Progress Apparels (Bangladesh) Ltd. (Extension)

MS-SFB 01& 02, Adamjee EPZ, Shiddirganj, Narayanganj.
(23.670782419, 90.5122804642)

11 December 2023

Schedule of Steel Rafter

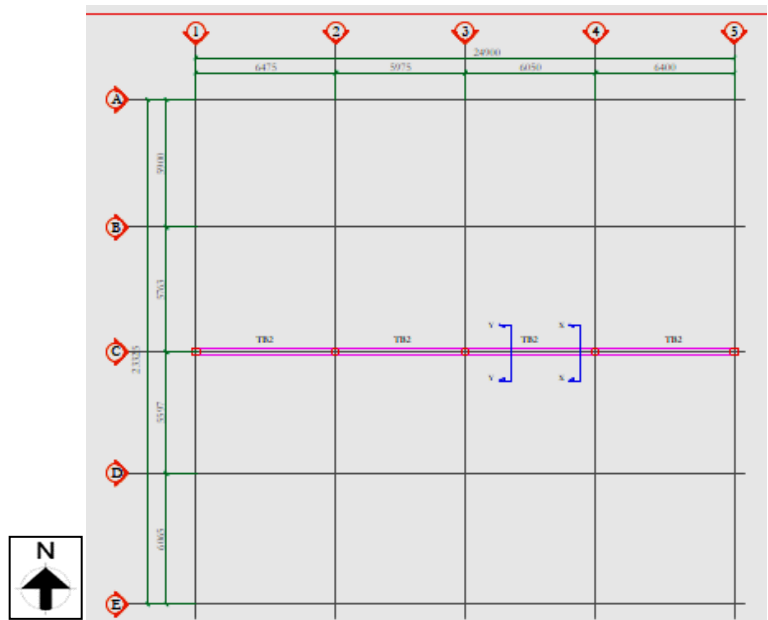
~9mm Flange thickness
of R101 onsite

~8mm Flange thickness
of R104 onsite

Description: During the inspection, flange thickness of R101, R102 and R104 were found 9mm instead of 12mm, and 8mm instead of 10mm respectively. And the depth of tie beam at level +5682mm was found 300mm instead of 375 mm.

Observation	Action Plan	Timeline
Inadequate number of concrete cylinder test report (Utility Building).	The building engineer is required to confirm the design strength of in situ concrete by taking minimum 4 number of cores from lower-tier columns.	within 6 weeks
Inadequate number of concrete cylinder test report (Utility Building).	The building engineer is required to revise the design report based on in-situ material strength & actual soil bearing capacity and submit it to the RSC for review.	within 6 weeks
Inadequate number of concrete cylinder test report (Utility Building).	Carryout remedial works if required.	within 6 months
Discrepancy in as-built drawing (Wash & Maintenance Shed)	Building engineer is required to survey whole structure, prepare accurate as-built drawings as per site condition and update design report along with analysis file.	within 6 weeks
Discrepancy in as-built drawing (Wash & Maintenance Shed)	Carry out suggested remedial works if required.	within 6 months

Tie Beam Layout Plan (+5682 mm)

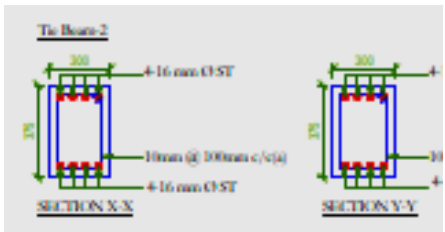
Tie Beam Size (300mm X 375mm)

Tie Beam Size found.
(300mm X 300mm)
